ROBINSON NUCLEAR PROJECT

PLANT MODIFICATION M-958

ADD AUTO START TO "B" SI PUMP

SAFETY EVALUATION FOR M-958  
"ADD AUTO START TO 'B' SI PUMP"

FIGURE 1

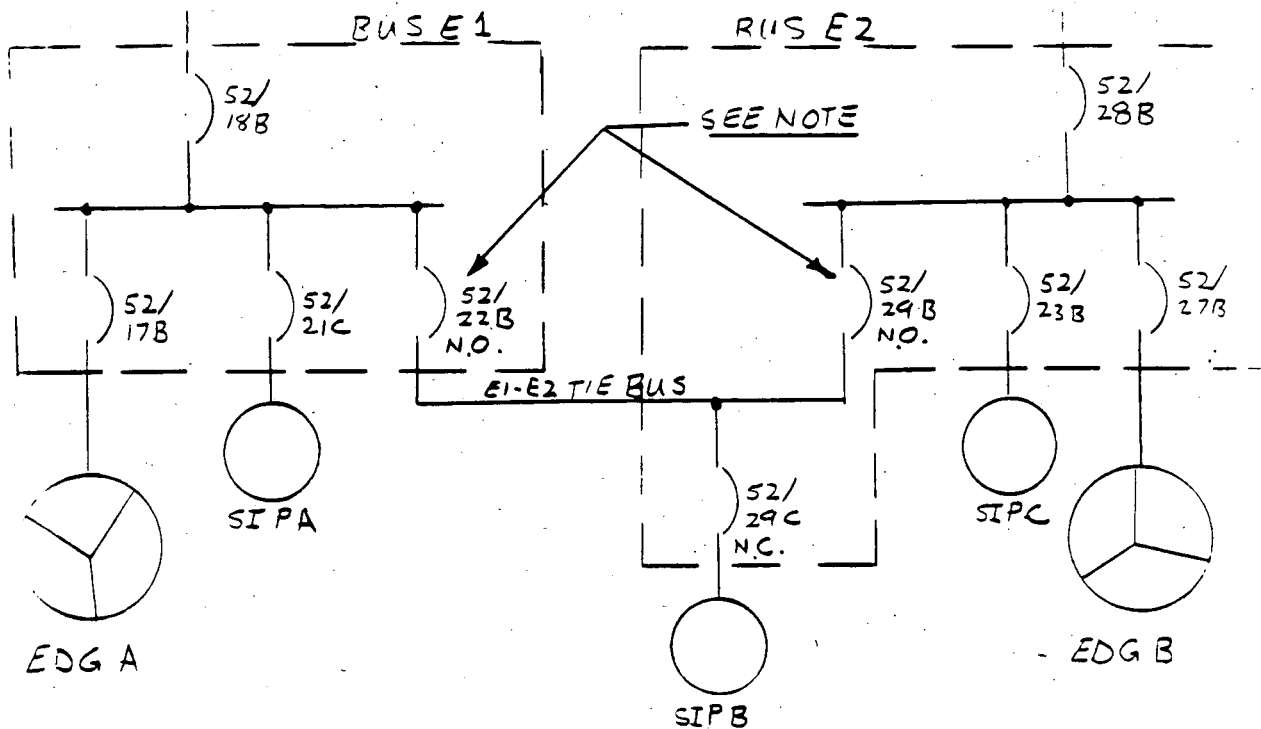
Changes will be initiated through POM change requests which will align the EI-E2 Tie Breakers 52/22B and 52/29B (see Figure 1) so that both breakers will normally be racked out. Either 52/22B or 52/29B will be racked in when the "B" SI pump is used to replace the "A" or "C" SI pump when they are out of service.

A human factors engineering review was performed on the "B" safety injection (SI) pump controls with the proposed changes and a deficiency was found. The proposed changes would align the "B" SI Pump Feeder Breaker 52-29C (see Figure 1) so that it remains closed all the time and the

FIGURE 2

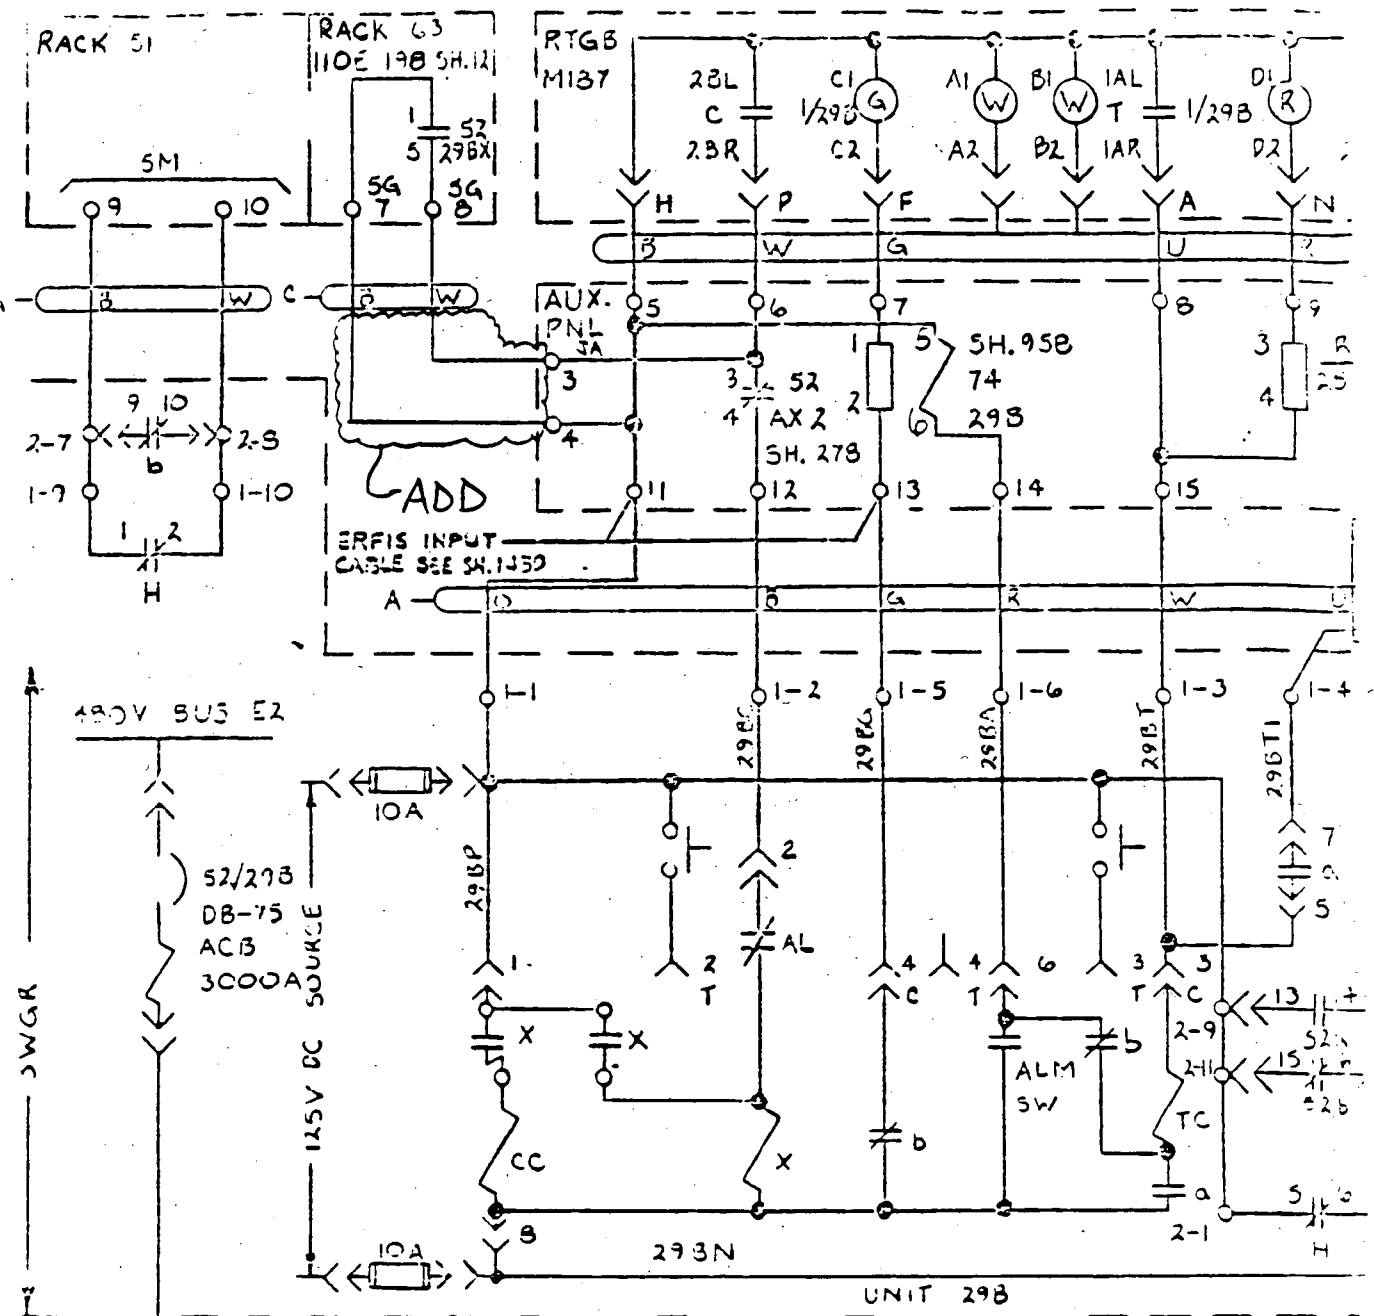
The auto start contact from the safeguards racks will be wired into the close circuits of the two E1-E2 tie breakers (see Figures 2 and 3). For Breaker 52/29B Cable C2896C will be terminated on Terminals 3 and 4 of Auxiliary Panel JA. For Breaker 52/22B Cable C2891C will be terminated on Terminals 3 and 4 of Auxiliary Panel FA. These cables are already in place and were determined at the auxiliary panels and tagged spare as part of Modification 951. With these cables reconnected, the "B" SI pump will start

FIGURE 4

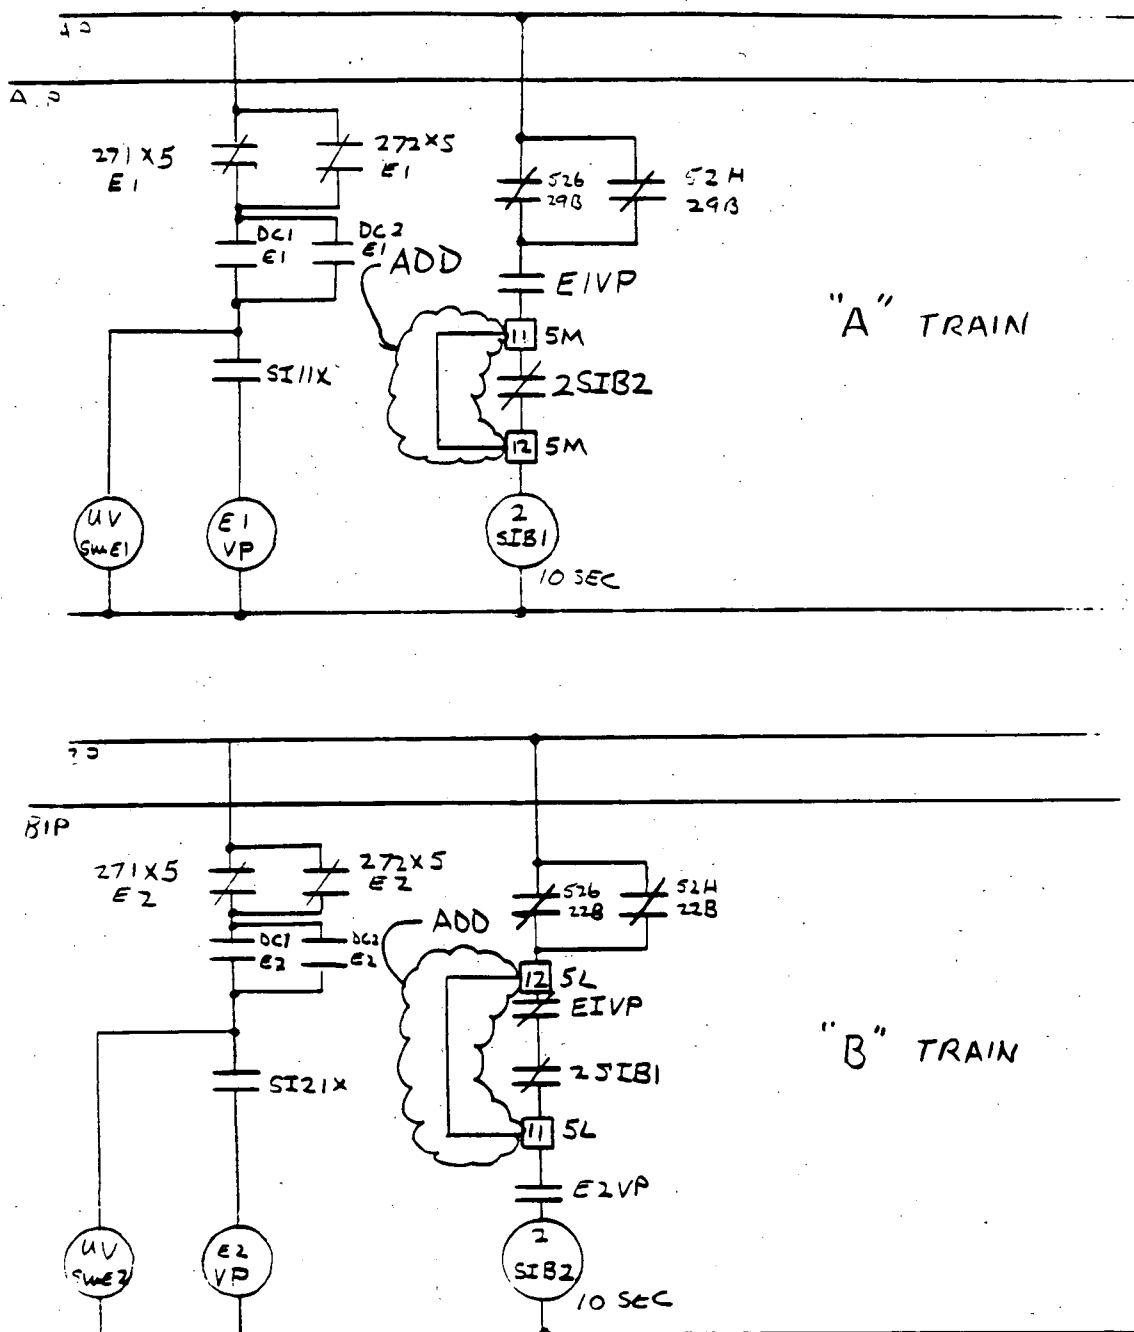
A jumper will be placed between Terminals 5M-11 and 5M-12 of Safeguards Rack 51 ("A" train) and a jumper will be placed between Terminals 5L-12 and 5L-11 of Safeguards Rack No. 63 ("B" train) (see Figure 4). These jumpers ensure that a close command is given to both Breakers 52/22B and 52/29B. These jumpers bypass contacts which would prevent both sequencing trains from timing out which would initiate a close command to Breakers 52/22B and 52/29B. These jumpers also bypass a contact which served to select the EI bus for SI Pump "B" first. Since the "B" SI pump will be manually prealigned to one bus by racking out the unwanted breaker, these contacts are no longer needed.

FIGURE 1

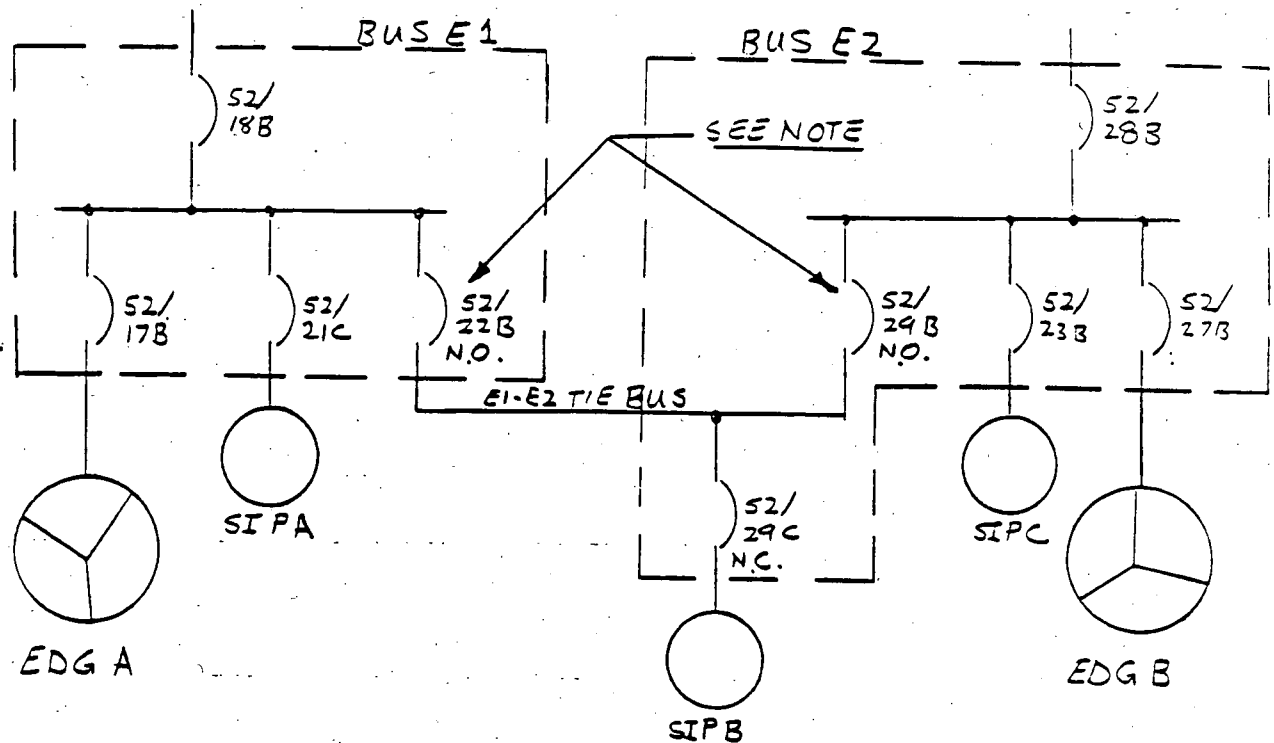
Changes will be initiated through POM change requests which will align the E1-E2 Tie Breakers 52/22B and 52/29B (see Figure 1) so that one breaker will be racked in and one breaker will be racked out when the "B" SI pump is used to replace "A" or "C" SI pump. Breakers 52/22B and 52/29B will normally be racked out with the control power fuses removed.

FIGURE 2

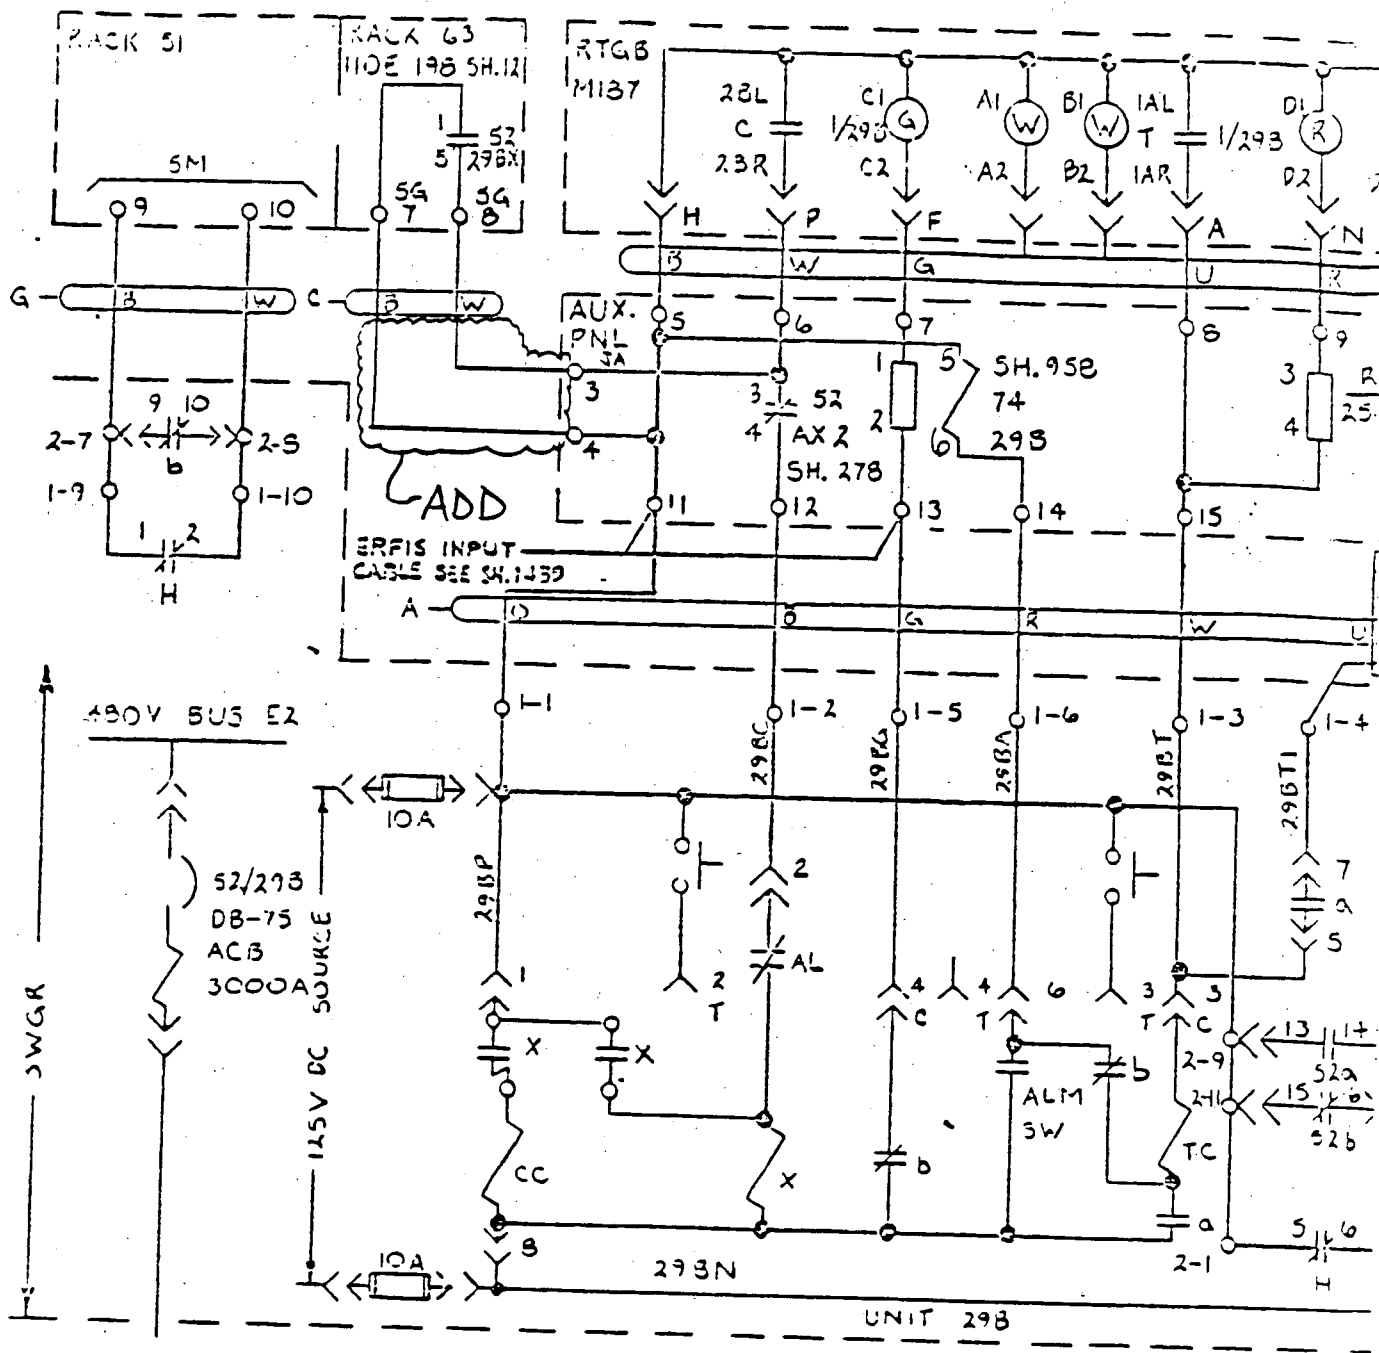
The auto start contact from the safeguards racks will be wired into the close circuits of the two E1-E2 tie breakers (see Figures 2 and 3). For Breaker 52/29B, Cable C2896C will be terminated on Terminals 3 and 4 of Auxiliary Panel JA. For Breaker 52/22B, Cable C2891C will be terminated on Terminals 3 and 4 of Auxiliary Panel FA. These cables are already in place and were determined at the auxiliary panels and tagged spare as part of Modification 951. With these cables reconnected, the "B" SI pump will start 10 seconds after initiation of the safety injection signal, which is the same initiation sequence that was in effect prior to Modification 951.

FIGURE 4

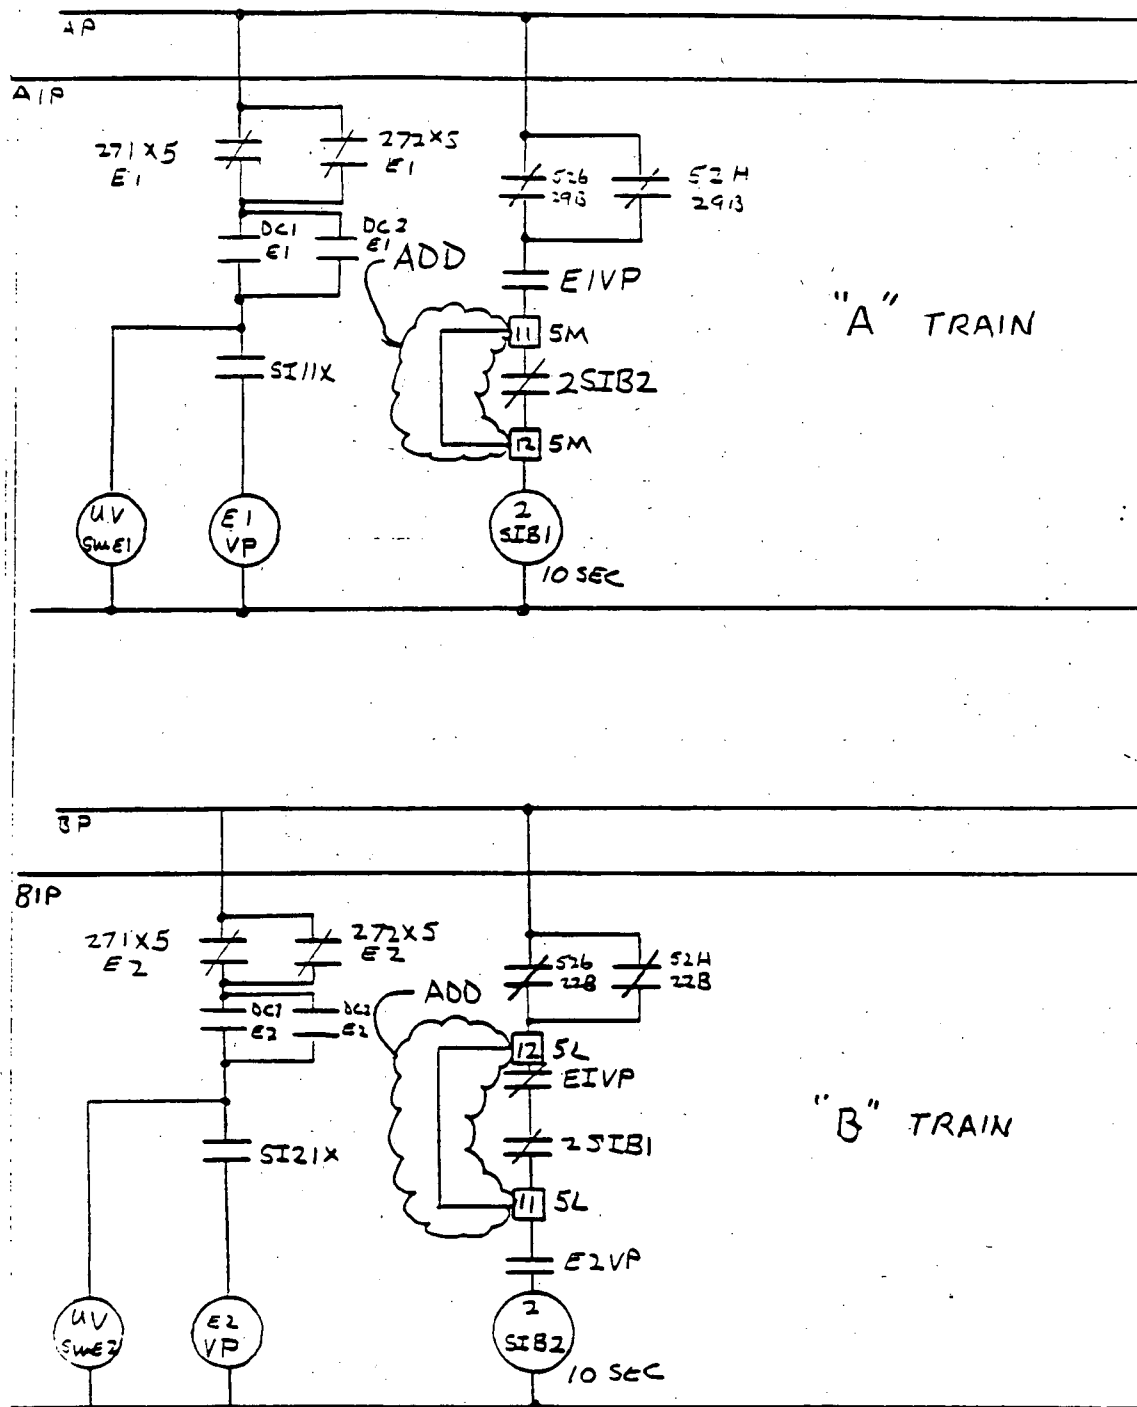
A jumper will be placed between Terminals 5M-11 and 5M-12 of Safeguards Rack 51 ("A" train) and a jumper will be placed between Terminals 5L-12 and 5L-11 of Safeguards Rack No. 63 ("B" train) (see Figure 4). These jumpers ensure that a close command is given to both Breakers 52/22B and 52/29B. These jumpers bypass contacts which would prevent both sequencing trains from timing out which would initiate a close command to Breakers 52/22B and 52/29B.

CAROLINA POWER & LIGHT CO. H.B. ROBINSON STEAM ELECTRIC PLANT
					SAFETY RELATED
					CONTROL WIRING DIAGRAM
A	14 JUNE 35	ISSUED FOR MOD-958	JM <del>TRE</del>	AC	
REV NO.	DATE	DESCRIPTION	DRAWN BY J.M.D.	RV.WD	APPR.
					REF. DWG. B-190628 SHT. 891, REV. 14
					SKETCH NO. SK-958 - Z-7000

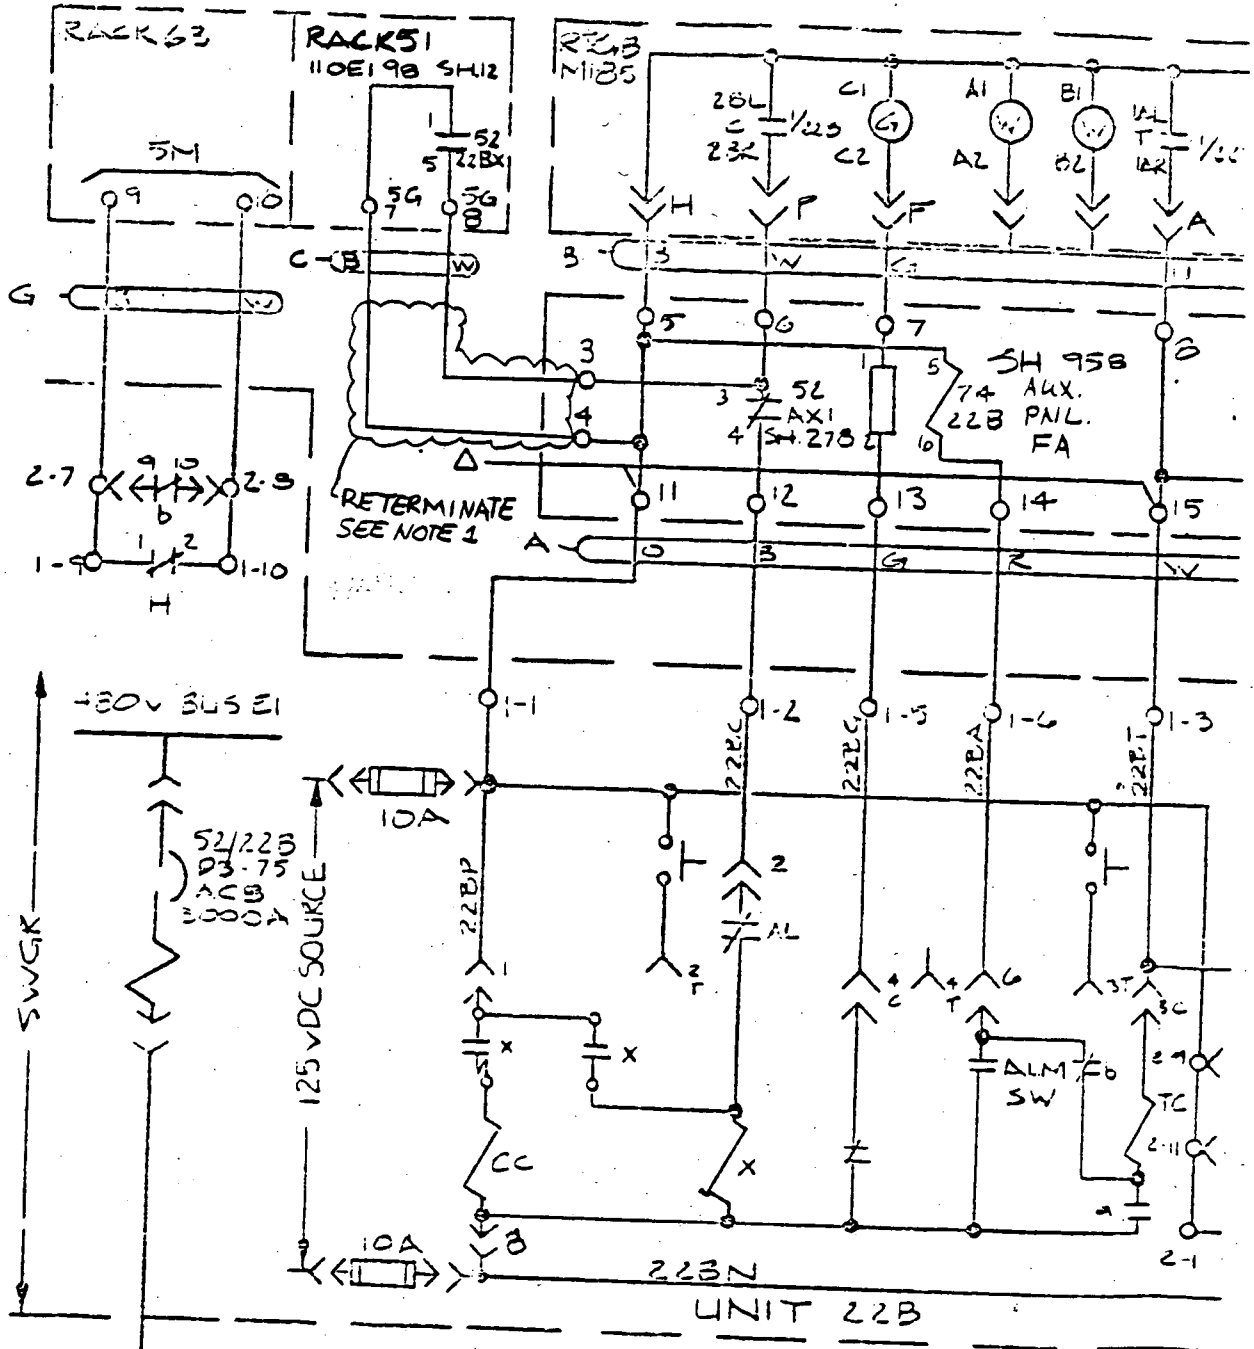
NOTE 1: CABLE C2891C WAS DETERMINATED AND LABELED SPARE PER MOD-951.  
RETERMINATE THIS CABLE ONI AUX PNL FA AS SHOWN.
